Dist	COUNTY	ROUTE	POST MILES TOTAL PROJECT	SHEET No.	TOTAL SHEETS
04	Ala	580	R7.8/19.1	2	681

ROUTE 580

(2) **REVISED PER ADDENDUM No. 2 DATED SEPTEMBER 19, 2012**

2 **ROUTE 580 REVISED PER ADDENDUM No. 2 DATED SEPTEMBER 19, 2012**

X-1

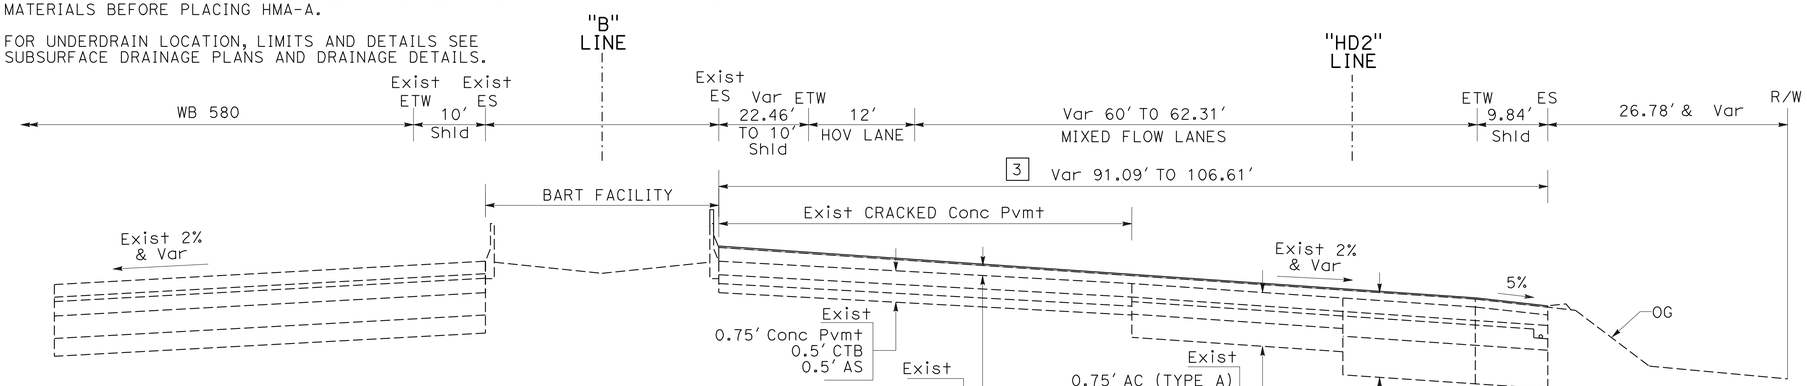
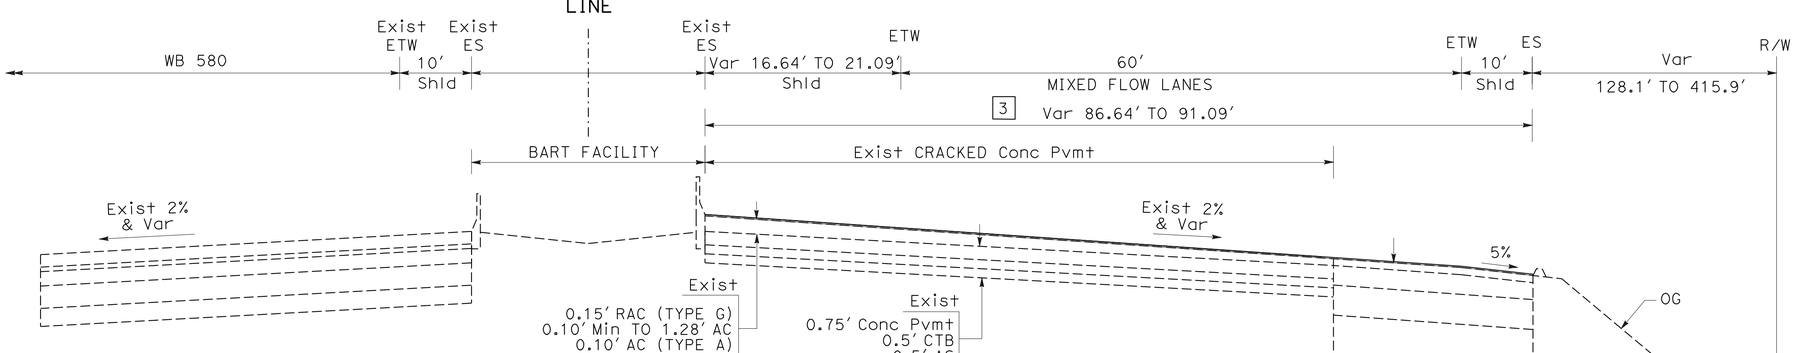
[6] 0.35' Conc Pvmt
0.50' ~~Cl 3 AB~~ Cl 2 AB (2)

X-6

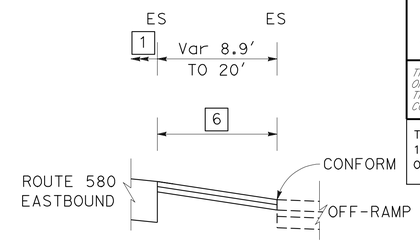
~~"B" 323+26.66 TO "B" 324+05.48~~ 2
"B" 423+27.29 TO "B" 424+04.18

SC-13

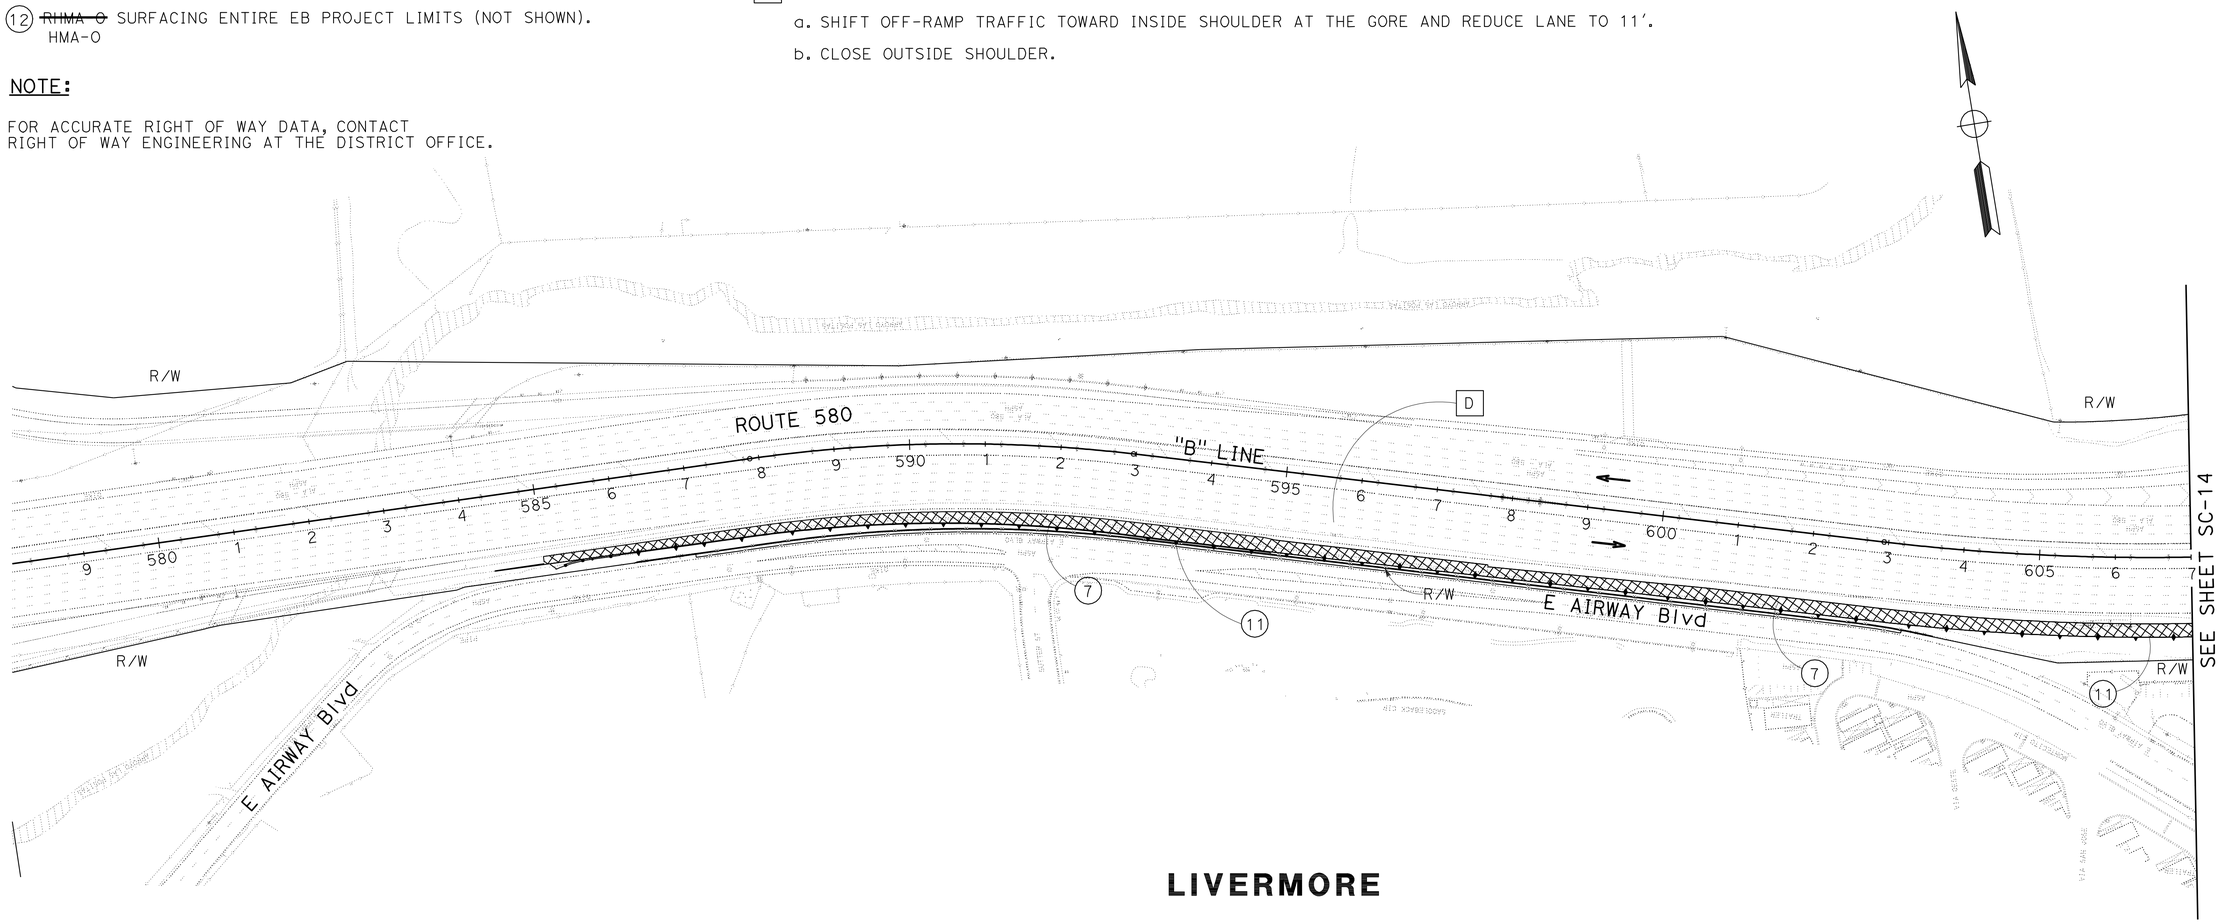
2 (12) ~~RHMA-O~~ SURFACING ENTIRE EB PROJECT LIMITS (NOT SHOWN).
HMA-O

2 **REVISED PER ADDENDUM No. 2 DATED SEPTEMBER 19, 2012**

ARROYO LAS POSITAS BRIDGE (WIDEN)
GIRDER REINFORCEMENT

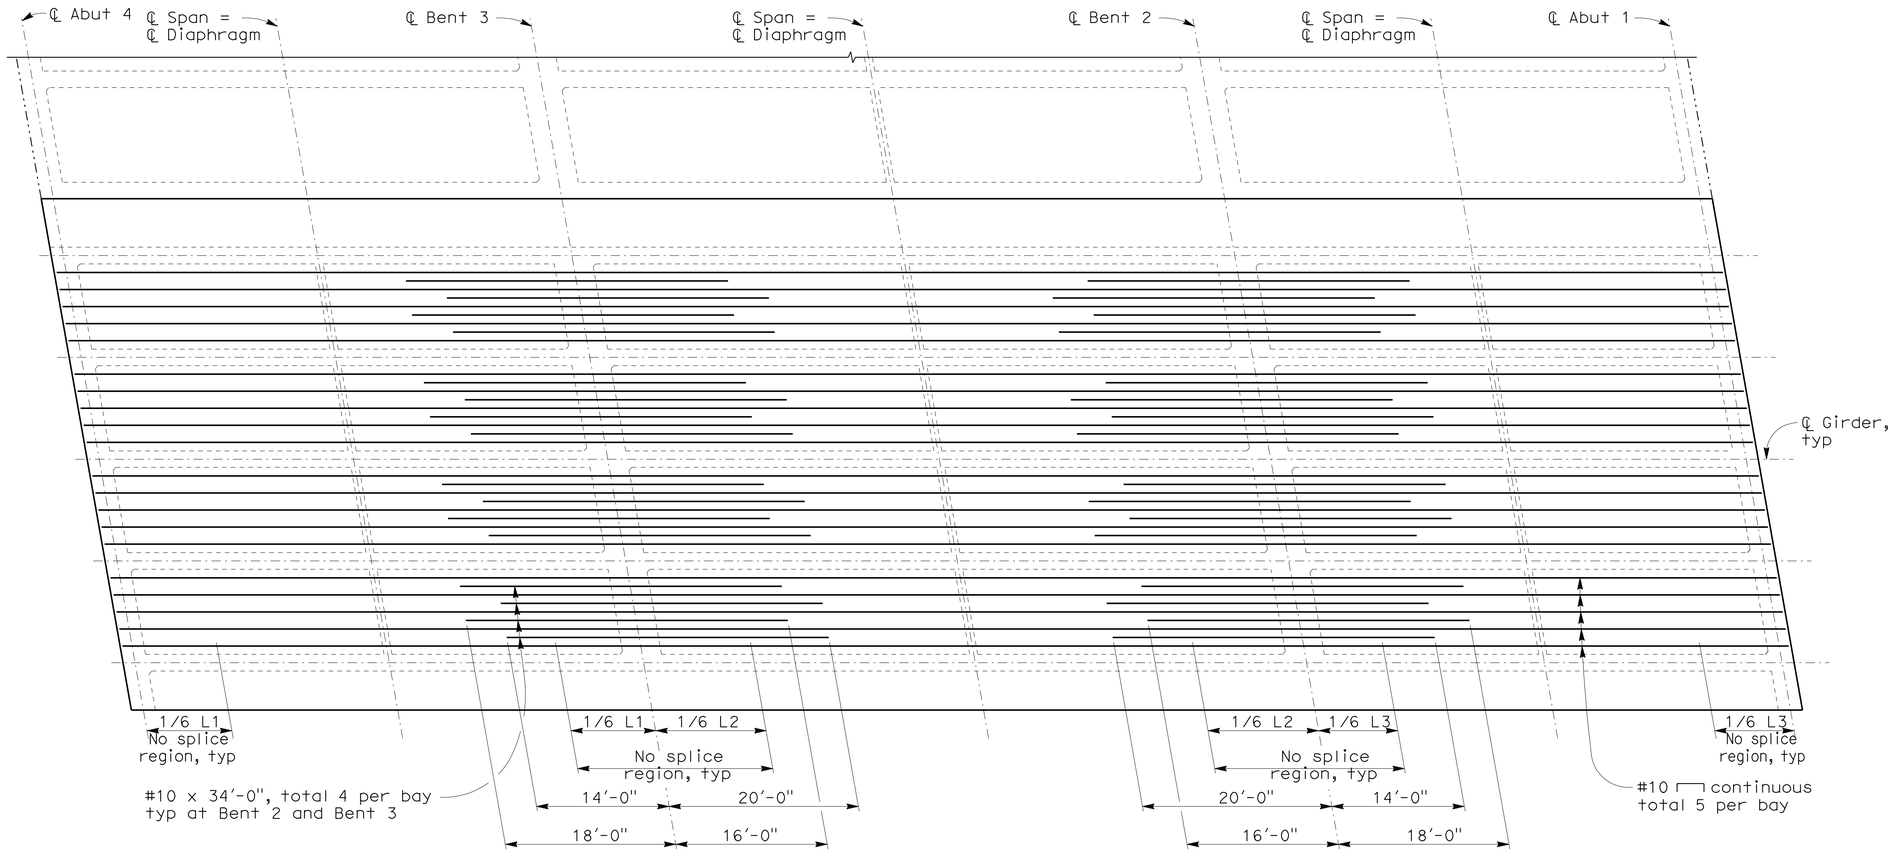
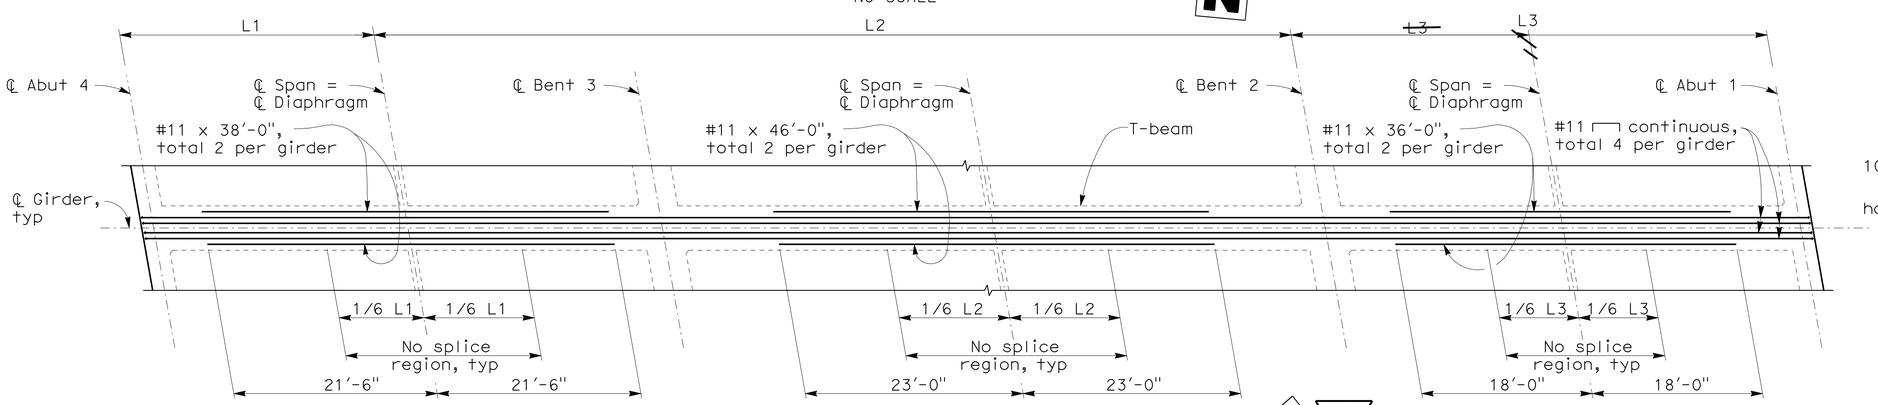
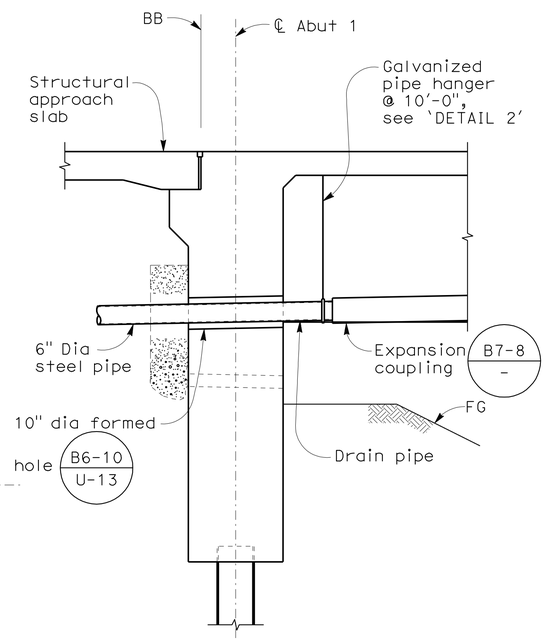
REVISED PER ADDENDUM No. 2 DATED SEPTEMBER 19, 2012

GENERAL PLAN NO. 3

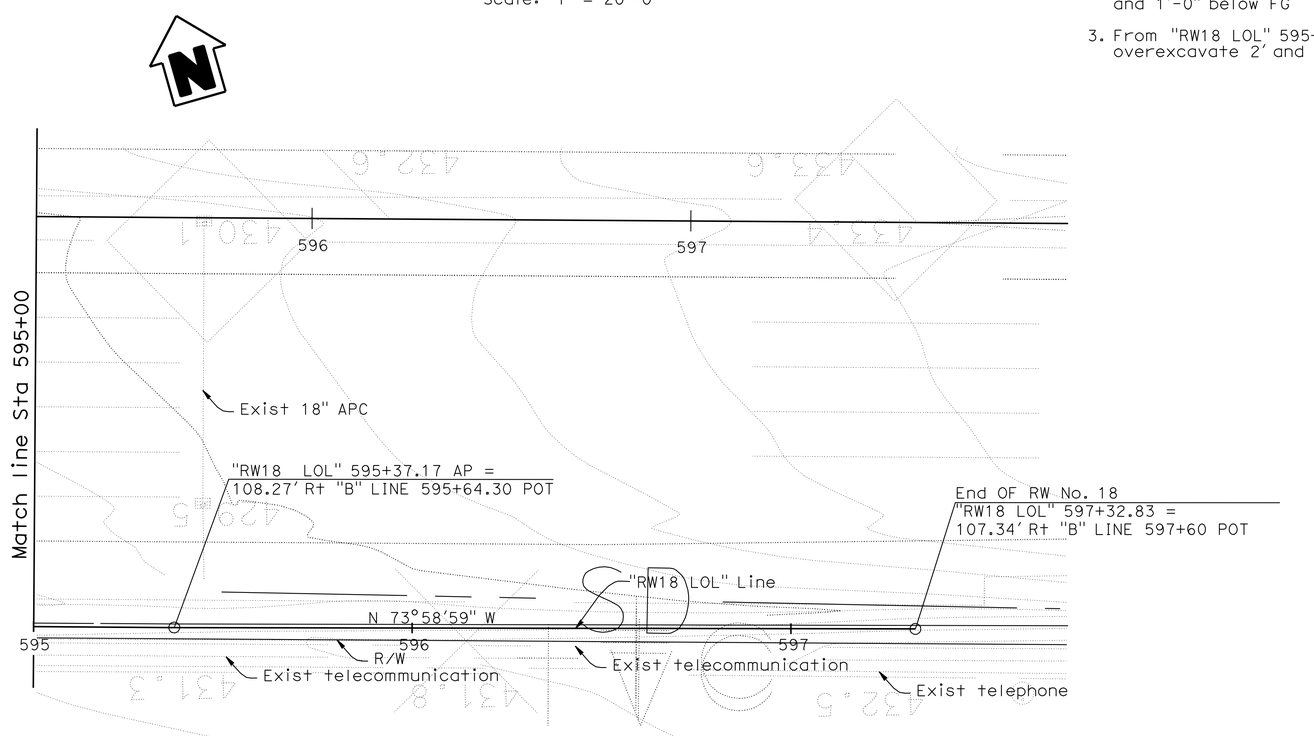
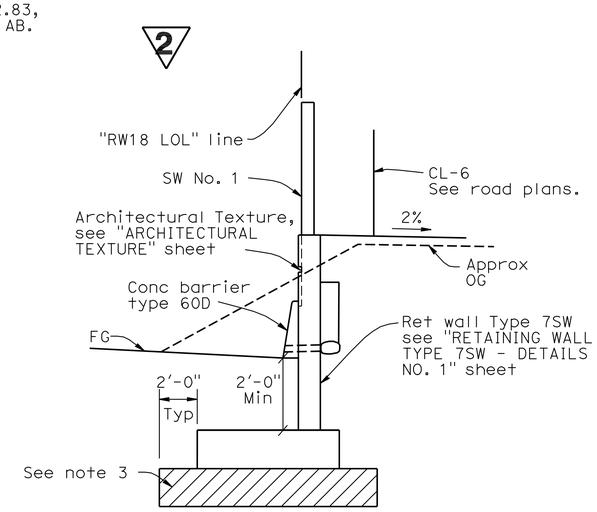
1. For weep holes and weakened planes locations and details see B0-3
2. Stop waterstop 6" above Conc Gtr FL and 1'-0" below FG
3. From "RW18 LOL" 595+64 to "RW18 LOL" 597+32.83, overexcavate 2' and backfill with compacted AB.

2 **REVISED PER ADDENDUM No. 2 DATED SEPTEMBER 19, 2012**
